## PLANNING DEPARTMENT STAFF REPORT AND FINDINGS

### ROLLING MEADOWS MINOR PARTITION – PRELIMINARY PARTITION APPROVAL (File MP 23–13)

#### Preliminary Partition Plan Map

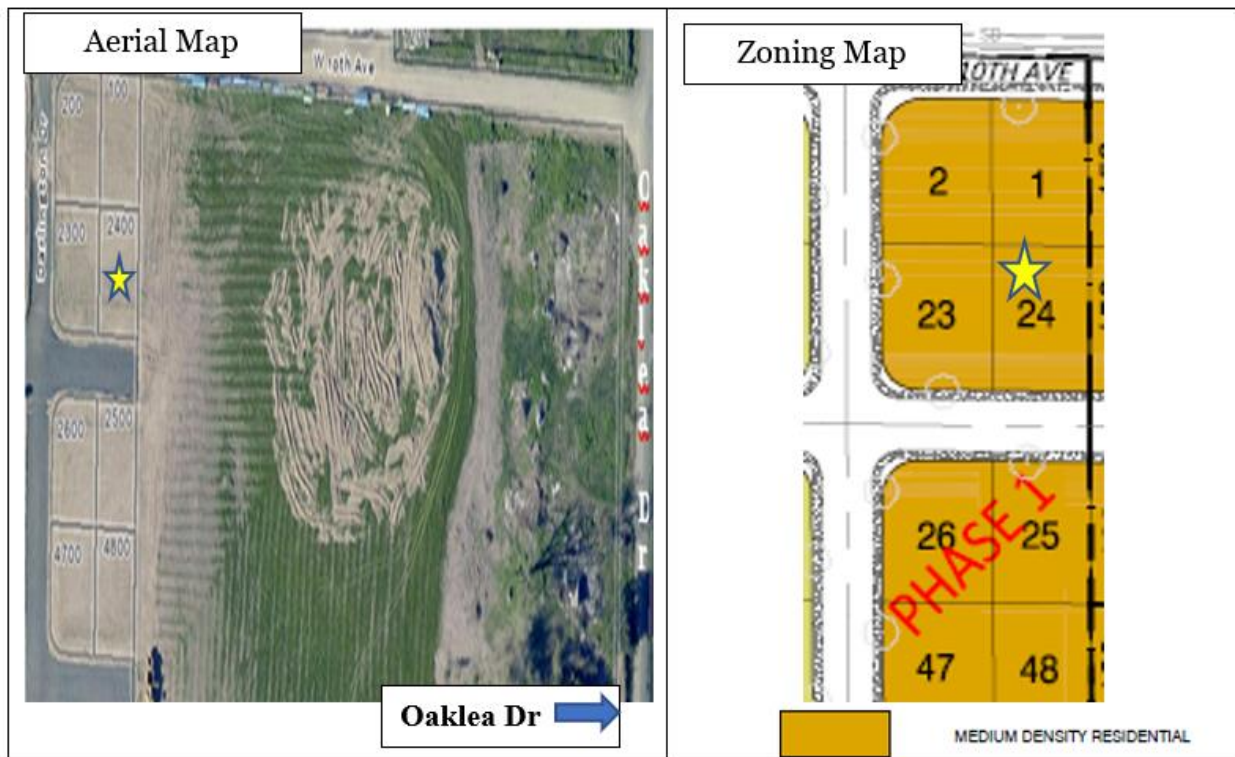
**Finding 7:** The preliminary plan has the dimensions of both parcels. The final plat must have this information.

**Finding 9:** The preliminary plan has the date, north point and scale of the drawing. The demensions of the property are adequately identified as adjacent tax lots are identified and numberd. The legal description of the property is Lot 24, Rolling Meadows PUD Phase 1. Neither the preliminary partition plan nor the supplemental materials identify the assessor's account number (Act #1914516).

**Finding 10:** The name and address of the owner/partitioner is present on the preliminary plan and its telephone number. However, the telephone number is included on the application form. The applicant's representative's name and address is listed on the preliminary plan as is Marcus Cross, the applicant's surveyor.

**Finding 12:** The preliminary plan depicts the layout of the proposed parcels and their number. The complete dimension of each parcel is included and their square footage.

**Finding 13:** The preliminary plan shows that the lot is vacant. The preliminary plan lists the setback standards associated with the R2 Zone.

**Finding 14:** The preliminary plan shows two water easements. These easements were dedicated to the City as part of the approval of Phase 1 of the Rolling Meadows Subdivision.

**Finding 33:** The preliminary plan shows a 10' wide public utility easement that has been dedicated to the City.

**Condition of Approval #1:** The final plat must show all easements. All easements must be recorded and the public utility easements dedicated to the City prior to final plat approval.
